Office Action Summary	Application No. 10/567,478	Applicant(s) NYSTROM, MARCUS	
	Examiner SEAN M. MICHALSKI	Art Unit 3724

DETAILED ACTION

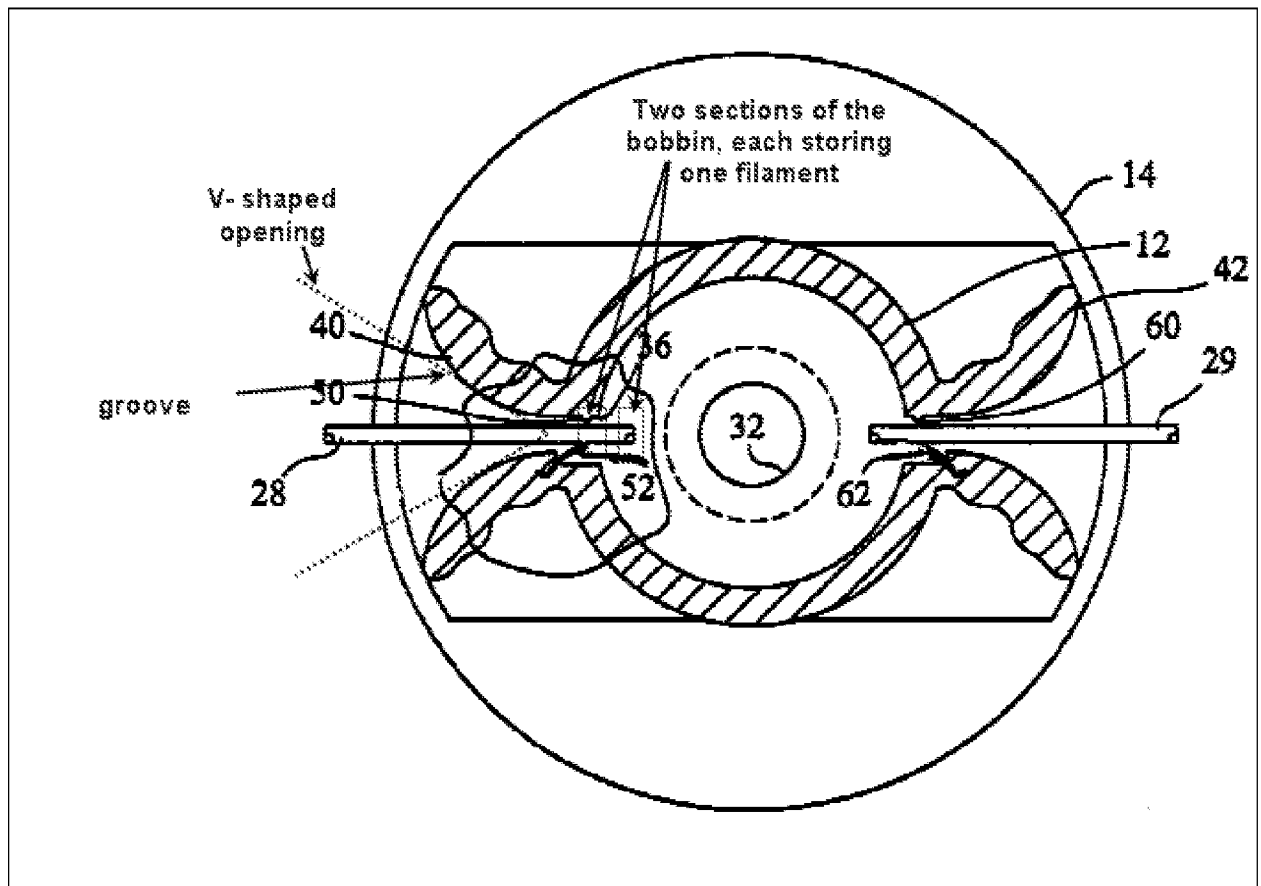
Fogle discloses a trimming head (14) including two eyelets (40/42 figure 4) and a bobbin (area interior of 62 is a bobbin, since that is the round area where the thread is stored), the eyelet provided with an opening (as seen in figure 4, through which filament 28 extends), the opening extending in an axial direction (the opening is three dimensional-therefore extends in all directions). Fogle discloses at least two sections in the bobbin capable of storing one cutting filament in each section, see below:

Are each of the "sections" shown above storing "a cutting filament"- Yes. Looking at them individually they may both be said to be storing a cutting filament, and they are both "sections" of the bobbin.

Fogle teaches a V-shaped opening, including a groove, as seen in the figure above.
